Agenda NFPA Technical Committee on Lightning Protection NFPA 780 Second Draft Meeting (A2025)

NFPA Technical Committee on Lightning Protection (LIG-AAA) NFPA 780 First Draft Meeting (A2025)

10.3.4.56

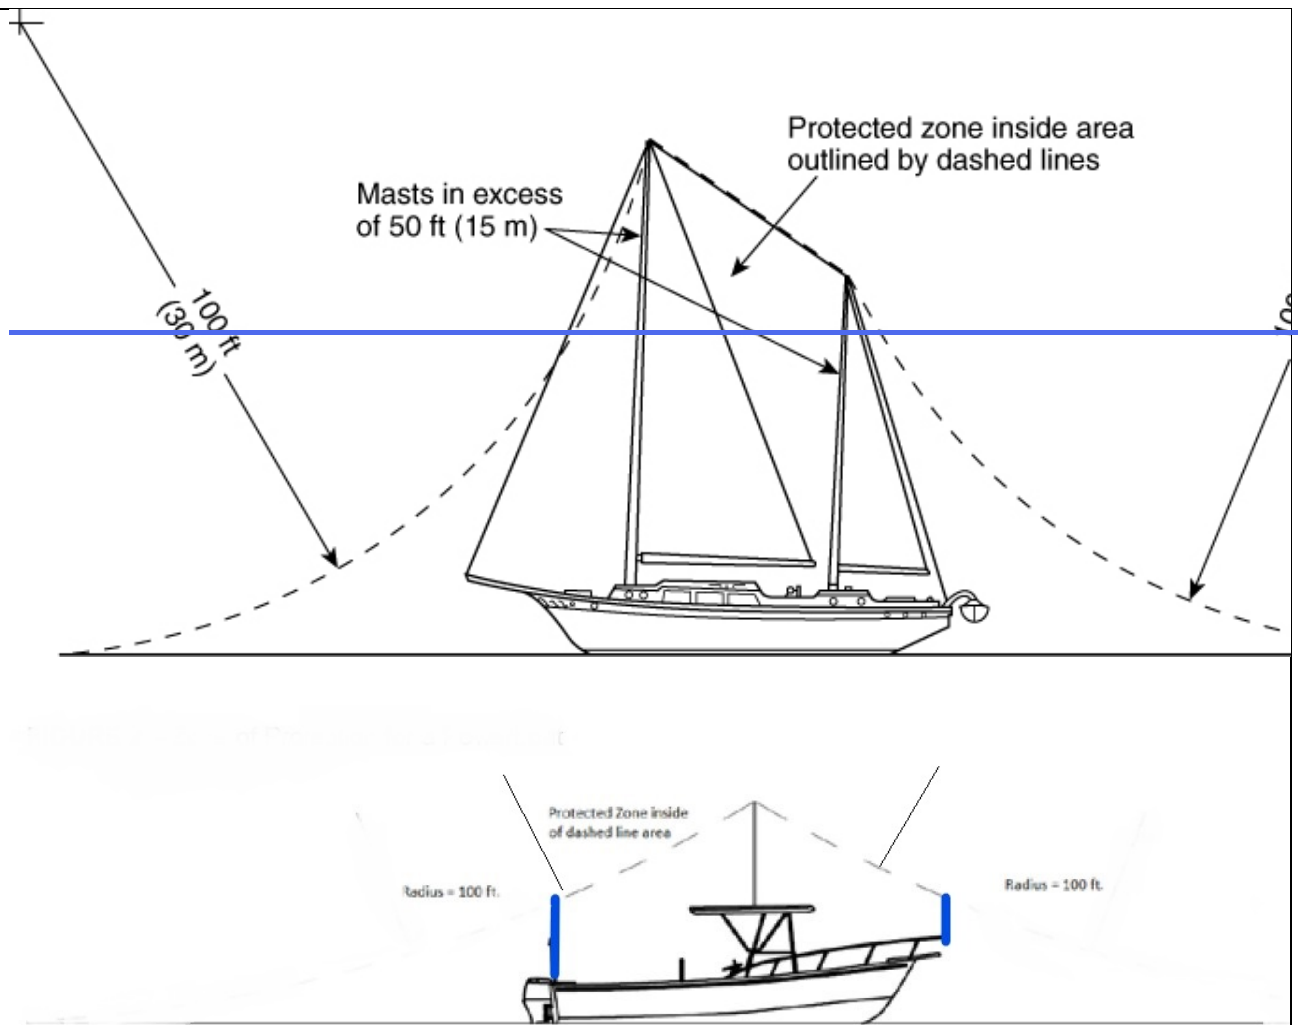
Strike termination devices, down conductors and connections to a carbon fiber mast shall be external to the mast.

Figure A.4.15.2.5.1 Illustration of Bonding Distance.

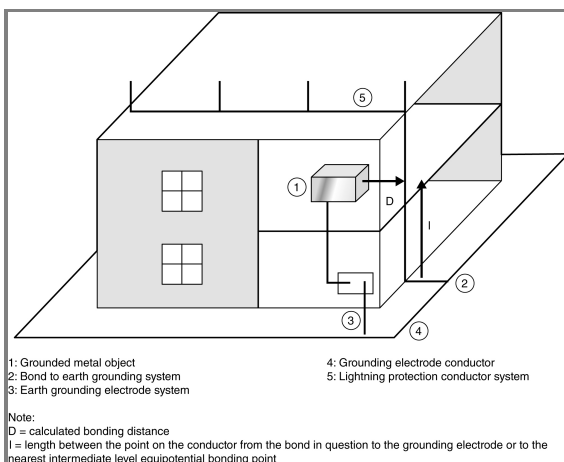
3. Grounding Electrode(also should this have a ground symbol like others in the standard?)
